Redline Markups

2023 City of Seattle Standard Plans for Municipal Construction

The Standard Plans shown here depict the proposed edits of the 2020 Standard Plans used to create the 2023 Construction Standards.

**TREE PROTECTION DURING
TRENCHING, TUNNELING OR
EXCAVATION**

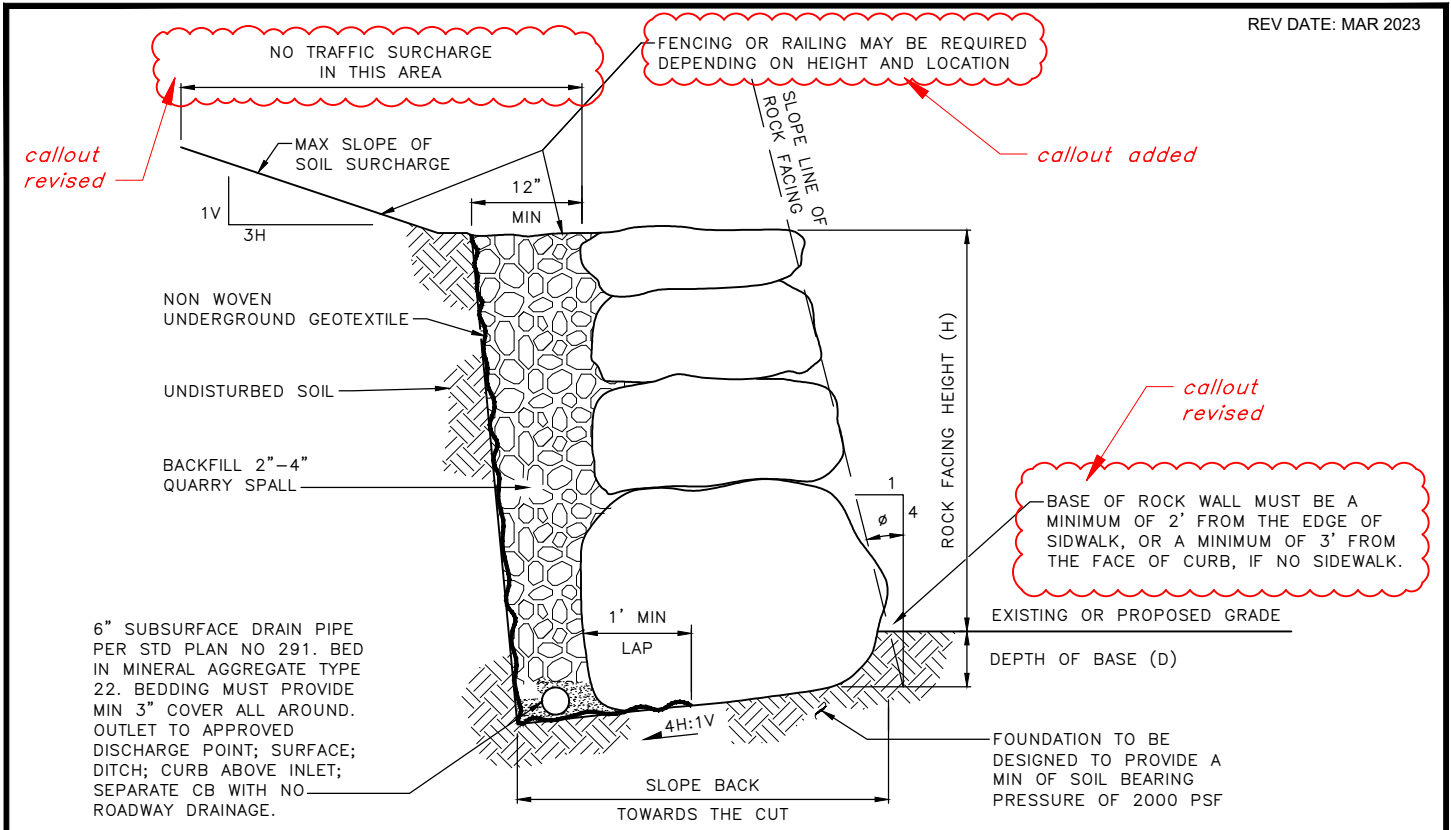
call-out added

dim revised

notes revised

**2'-0" DIAMETER
FRAME & COVER**

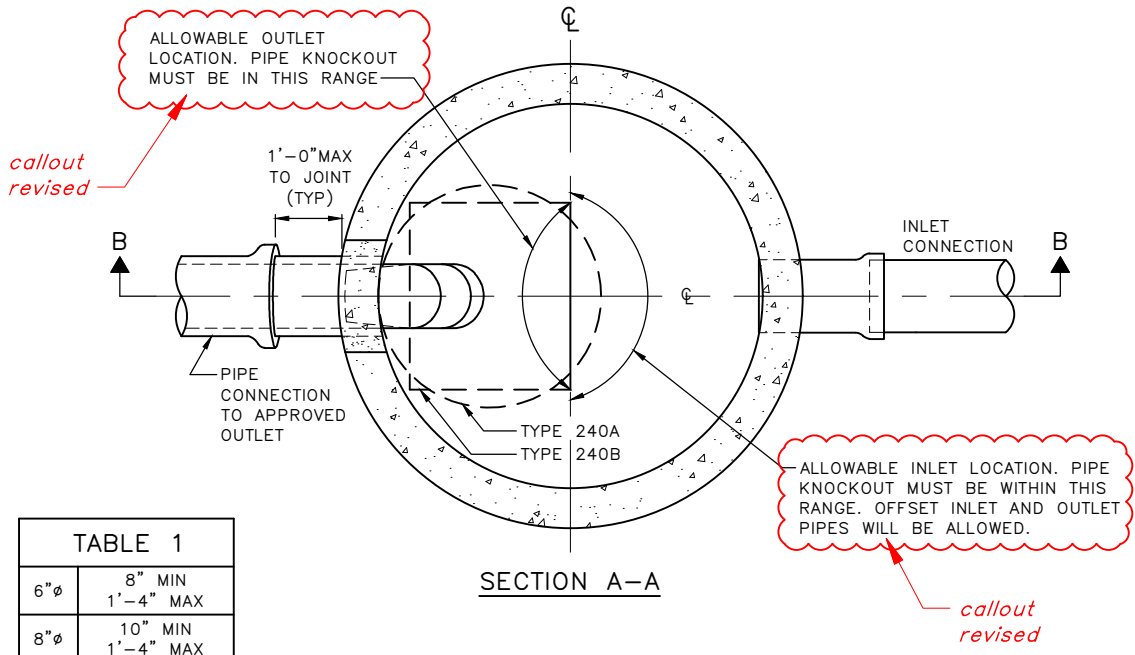
dim revised

note 5 added

TYPE 240 CATCH BASIN

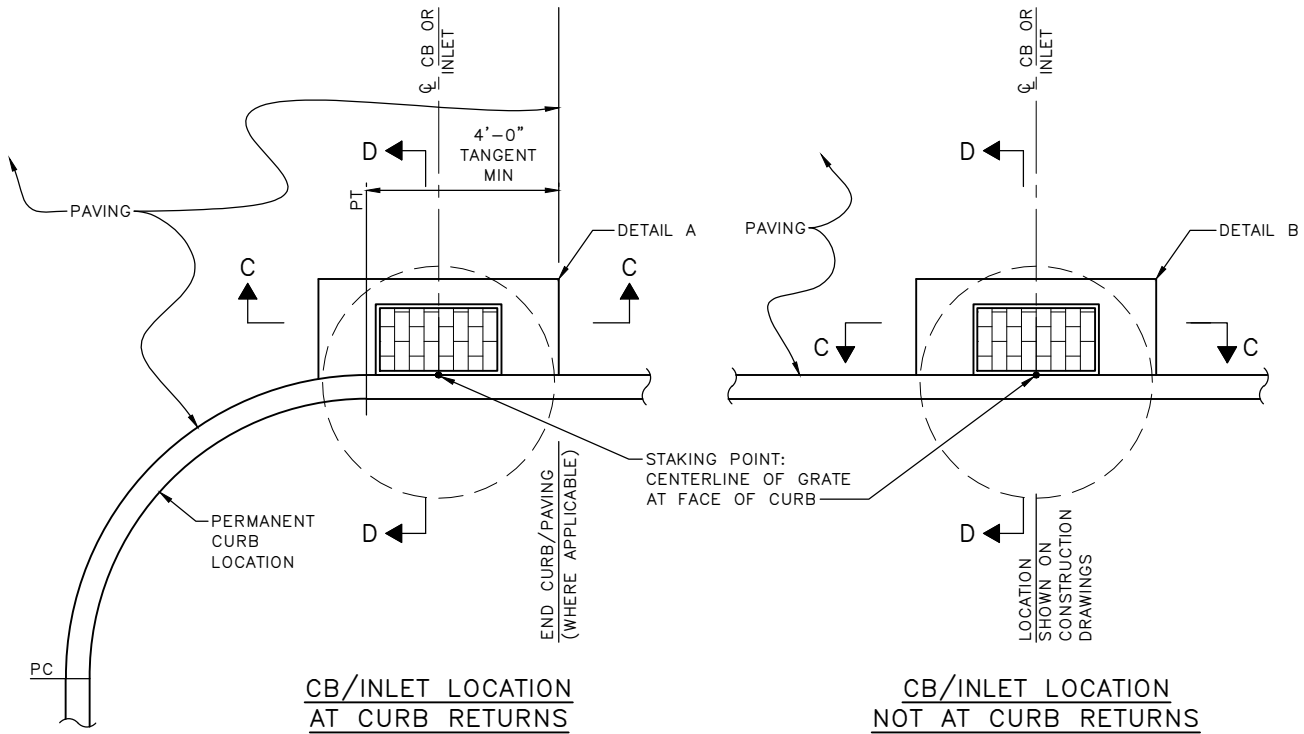
- note 3 added*
- NOTES:**
1. CB INLET GRATES MUST NOT BE PLACED IN CROSSWALKS.
 2. ~~CB INLETS MUST NOT BE PLACED IN CURB RAMP LANDINGS.~~
 3. CASTINGS LOCATED WITHIN THE CROSSWALK MUST BE ADA ACCESSIBLE.

VANED GRATES

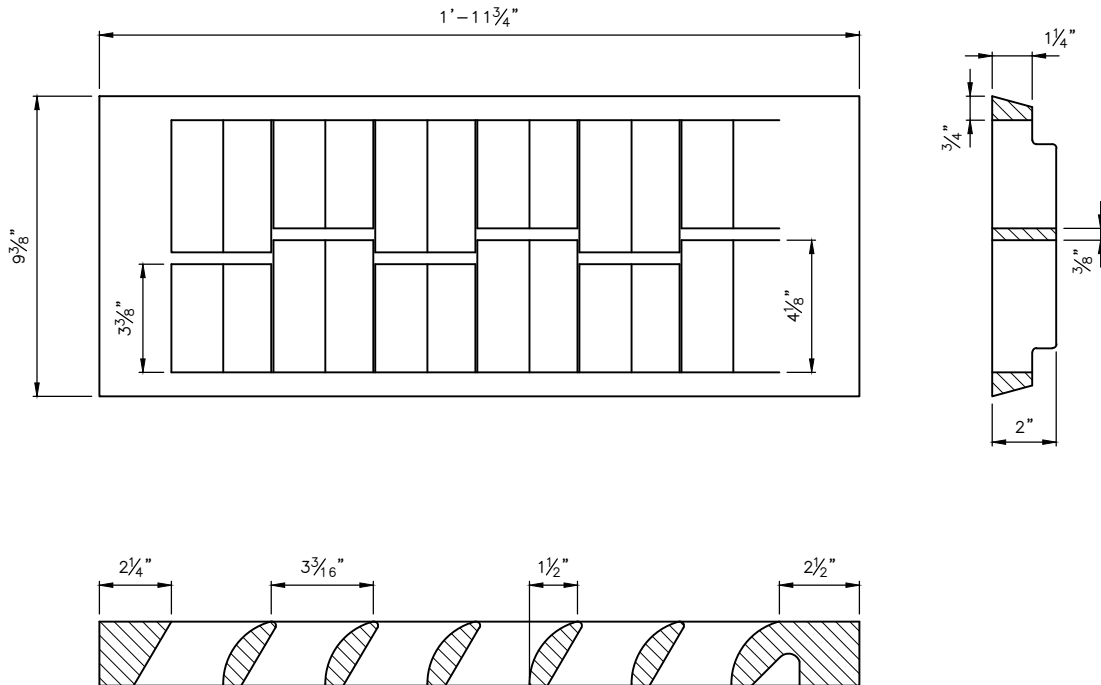
note 2 added

FLOW CONTROL STRUCTURE WITH DETENTION PIPE

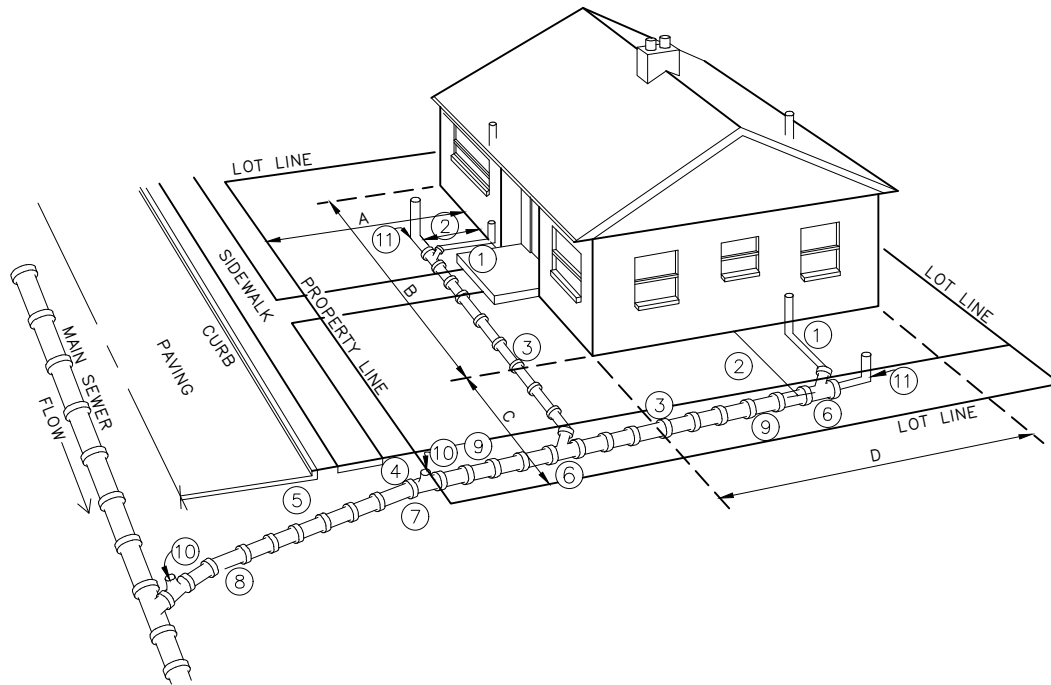
note 8 added

table removed

* note moved to above, *** note converted to Note 8

SEWER & WATER
SPACING & CLEARANCES

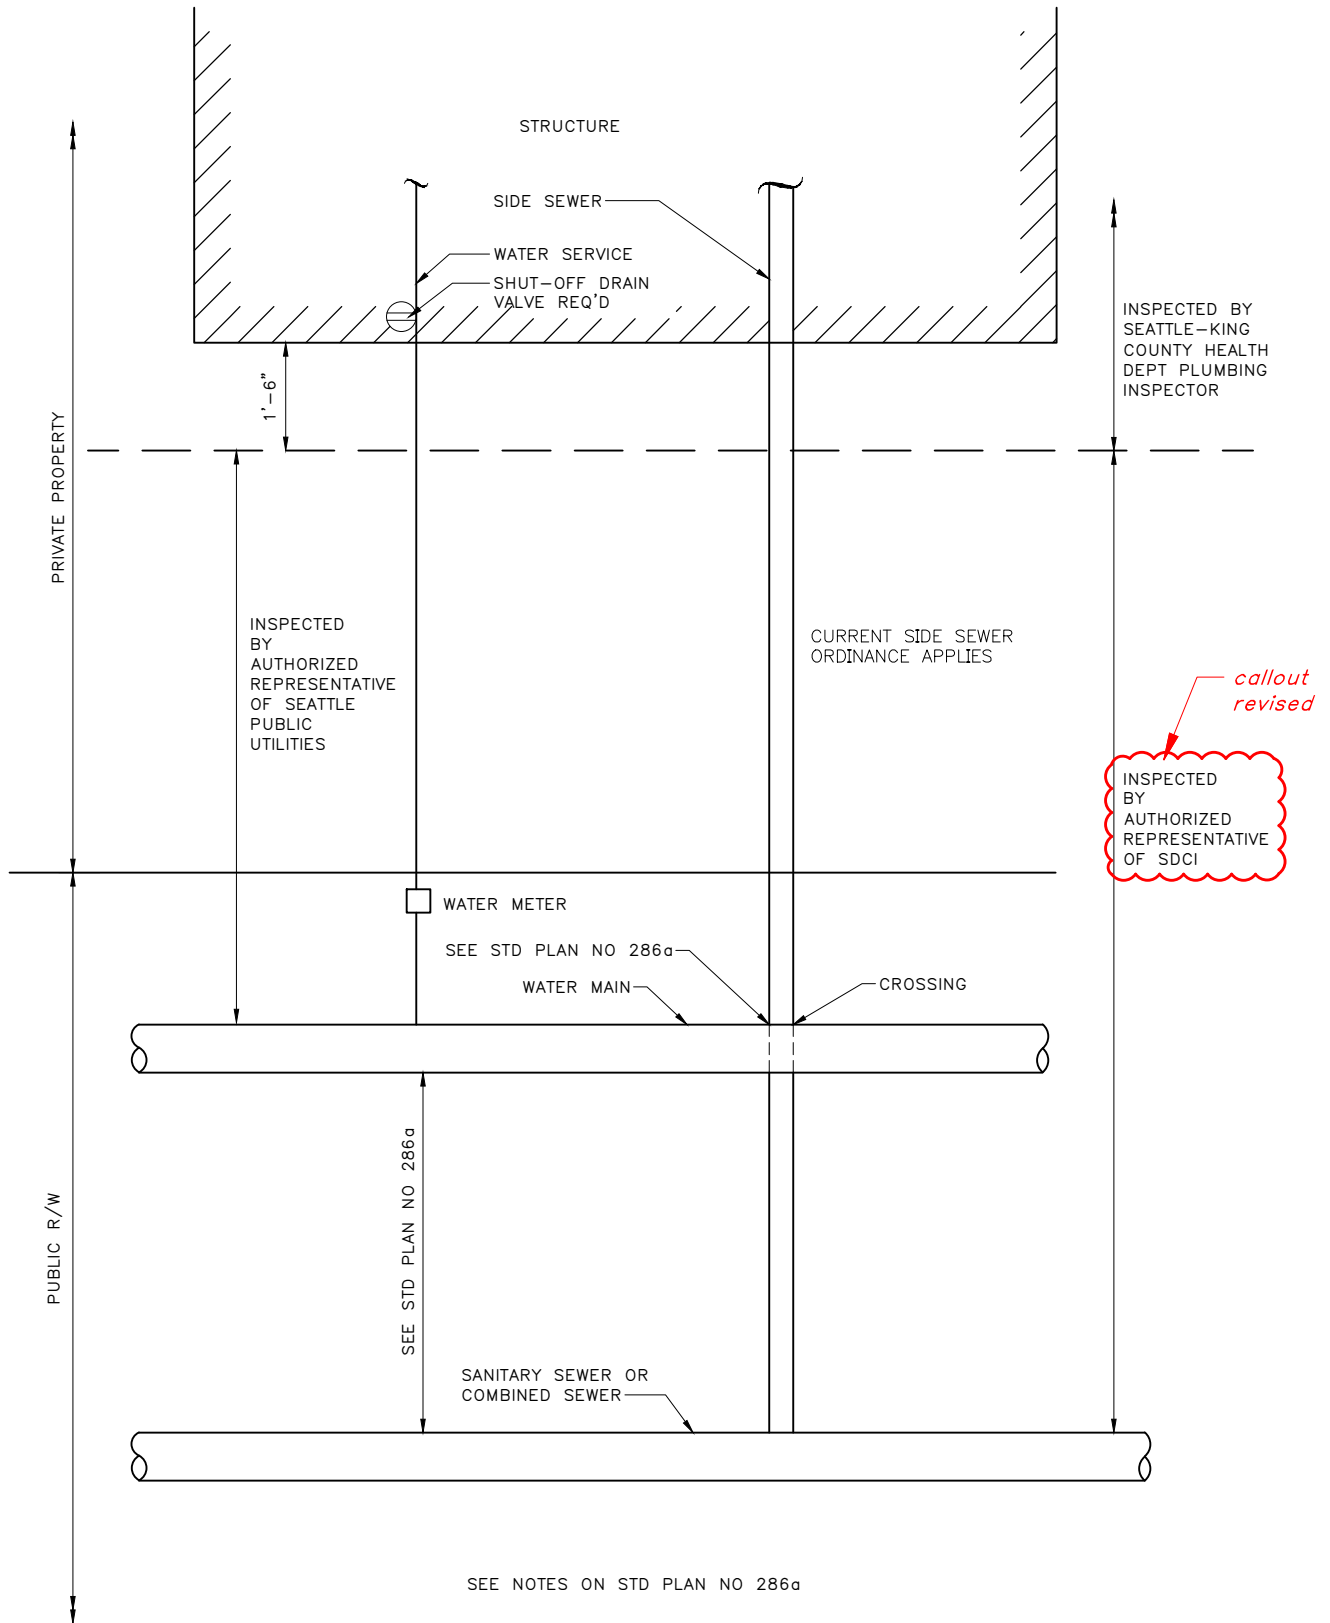
note revised

<p>City of Seattle</p>	<p>NOT TO SCALE</p>	<p>TYPE 310 HYDRANT SETTING DETAIL</p>
--	------------------------	---------------------	--

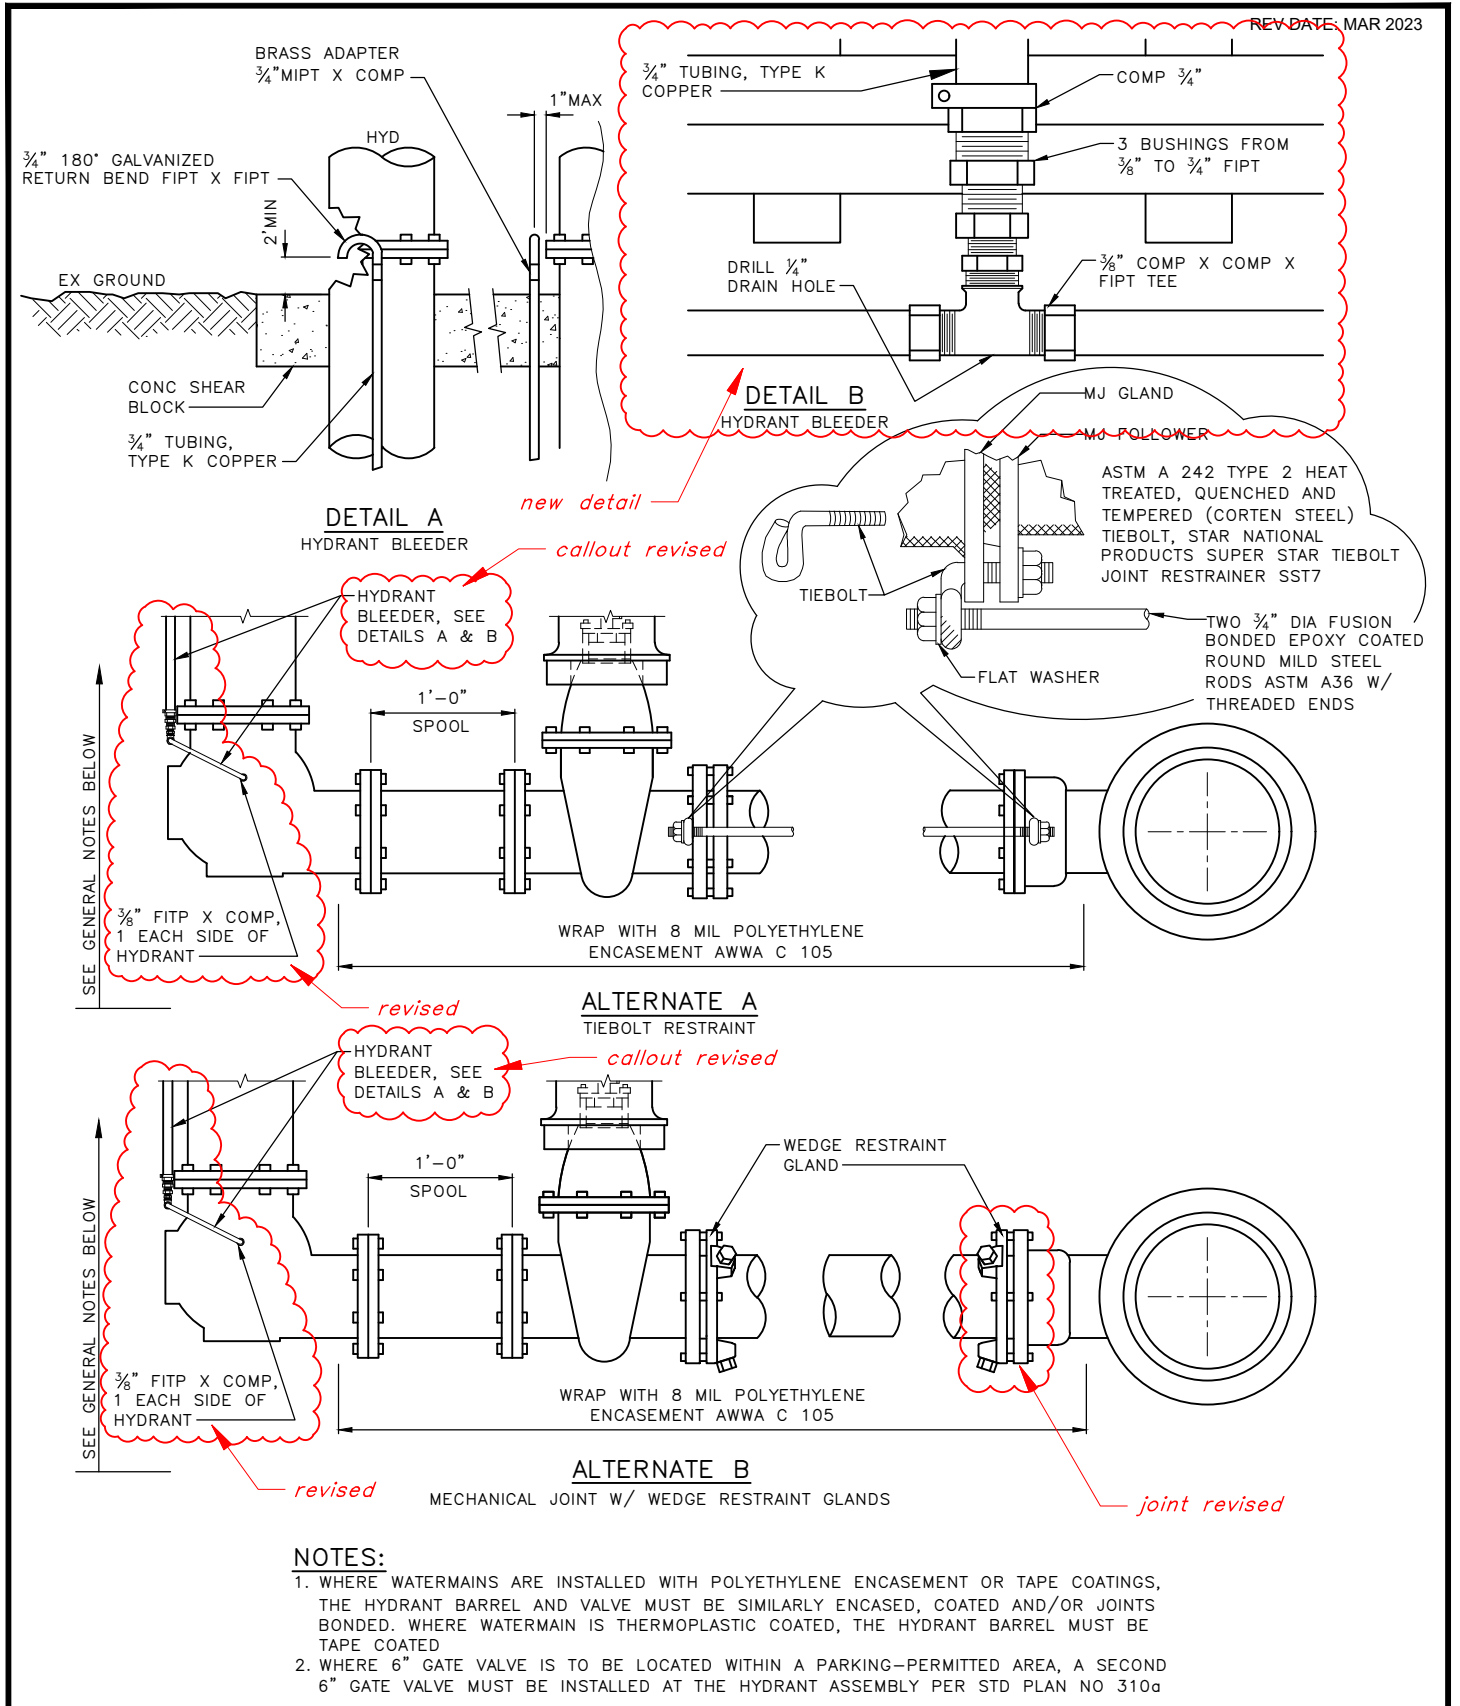
callout revised

revised
